Title IMU\_PCB\_2024\_VIAS02.PrjPcb

File: IMU\_PCB\_2024.SchDoc

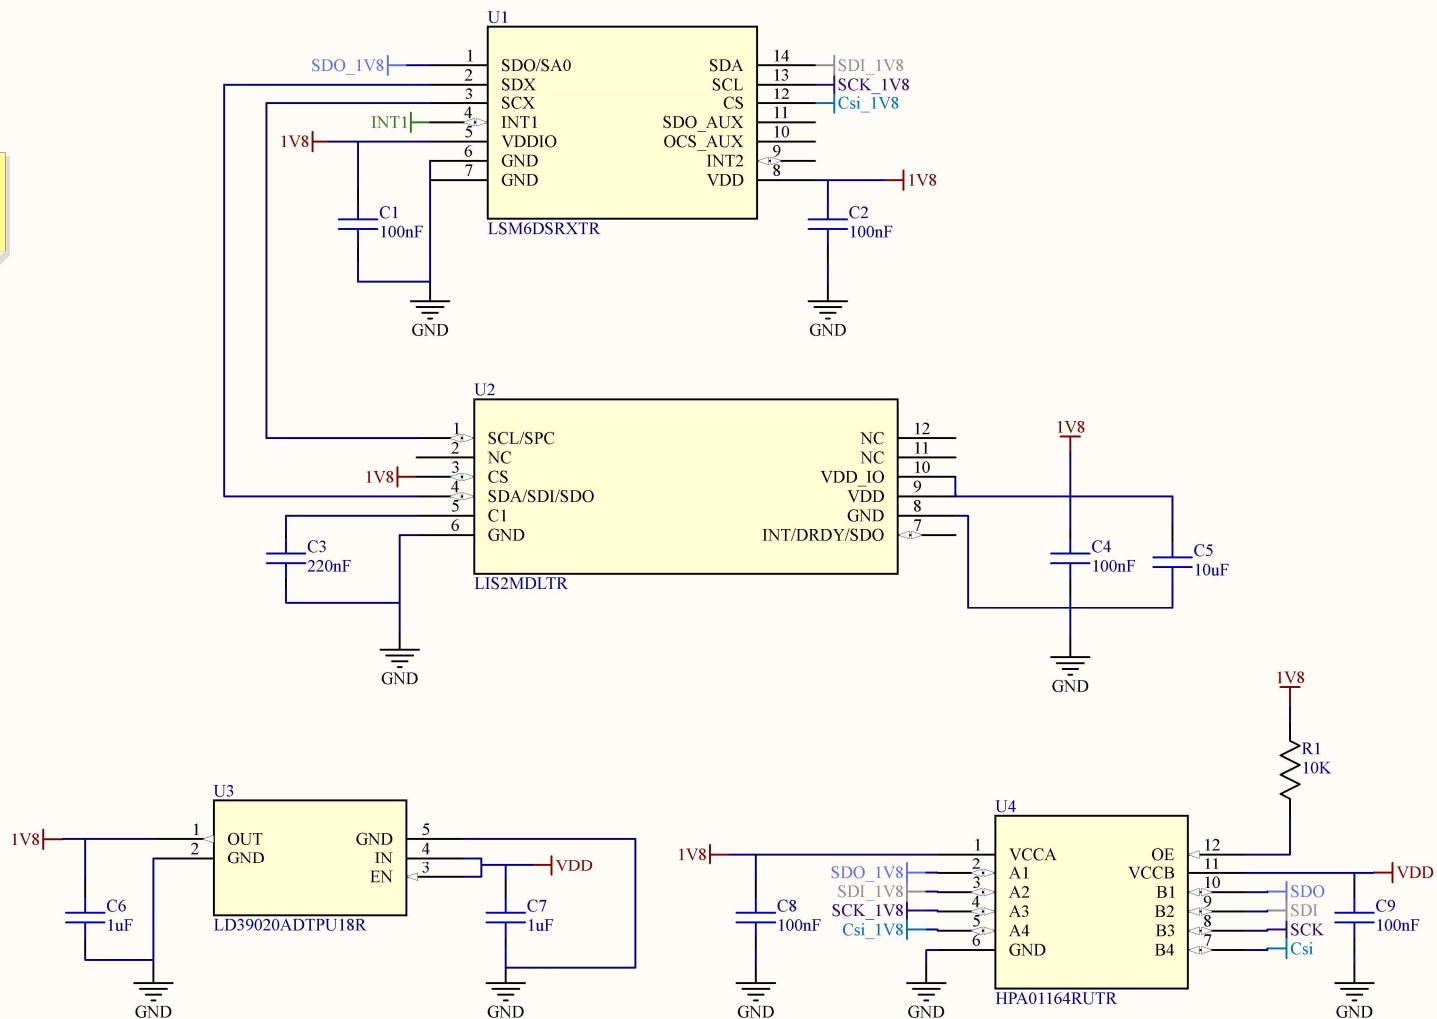
Added physical connection to unconnected pin 10 of OUT port to pin 4 (INT1) of LSM6DSRX for debug purposes
